Work Order ID 105548

Item Name: Dual High Back Seat Installation

DART SERVICE INSTRUCTION

TO AMEND INSTALLATION INSTRUCTIONS IIN-D350-689 REV. B AND INSTRUCTIONS FOR CONTINUED AIRWORTHINESS ICA-D350-689 REV. 1

FIGURE 1: UPDATES TO CROSS SECTIONS F-F AND M-M
With reference to Figures 5 and 7 of IIN-D350-689
(Figures 25-5 and 25-7 of ICA-D350-689)

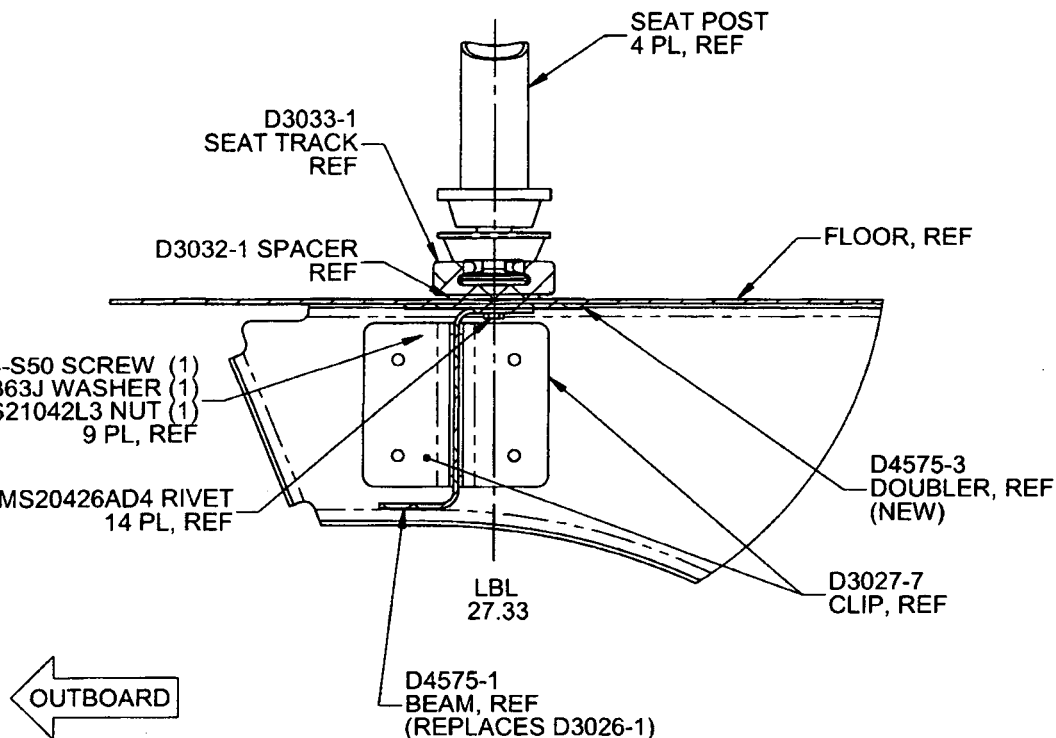
If there is an existing stringer at LBL 27.33, it will need to be removed from that location. Locate D4575-1 Beam, D4575-3 Doubler, and D3032-1 Spacer as shown in Figure 1 of this Service Instruction. Transfer drill existing holes from the aircraft floor to the D4575-1 Beam, D4575-3 Doubler, and D3032-1 Spacer. Ensure 1.0" to 1.5" rivet pitch and add additional holes if required. If there is no existing stringer, locate D4575-1 Beam, D4575-3 Doubler, and D3032-1 Spacer as shown in Figure 1 of this Service Instruction and drill Ø0.128" holes on a 1.0" to 1.5" pitch.

If there is an existing stringer at LBL 27.33, it will need to be removed from that location. Locate D4575-1 Beam and D4575-3 Doubler as shown in Figure 2 of this Service Instruction. Transfer drill existing holes from the aircraft floor to the D4575-1 Beam and D4575-3 Doubler. Ensure 1.0" to 1.5" rivet pitch and add additional holes if required. If there is no existing stringer, locate D4575-1 Beam and D4575-3 Doubler as shown in Figure 1 of this Service Instruction and drill Ø0.128" holes on a 1.0" to 1.5" pitch.

FIGURE 3: RELIEFS ON D4575-1/-3
(ONLY D4575-1/-3 SHOWN FOR CLARITY)
VIEW LOOKING INBOARD

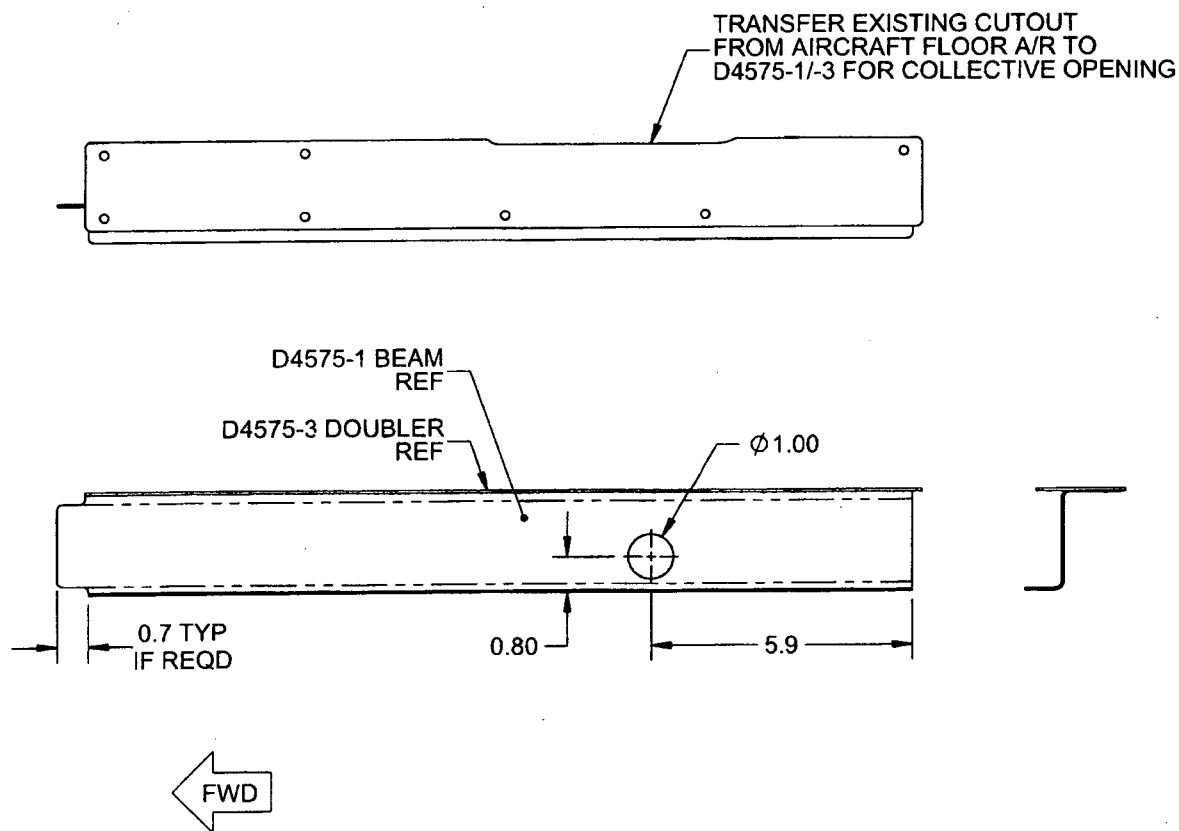
Note: Drill a Ø1.00" (Ø25.4 mm) hole in the D4575-1 Beam to clear extension tube of collective and cutout as required for clearance of collective opening and fwd bulkhead as shown in Figure 3 of this Service Instruction.

Note: Drill a Ø1.00" (Ø25.4 mm) hole in the D4575-1 Beam to clear extension tube of collective and cutout as required for clearance of collective opening and fwd bulkhead as shown in Figure 3 of this Service Instruction.
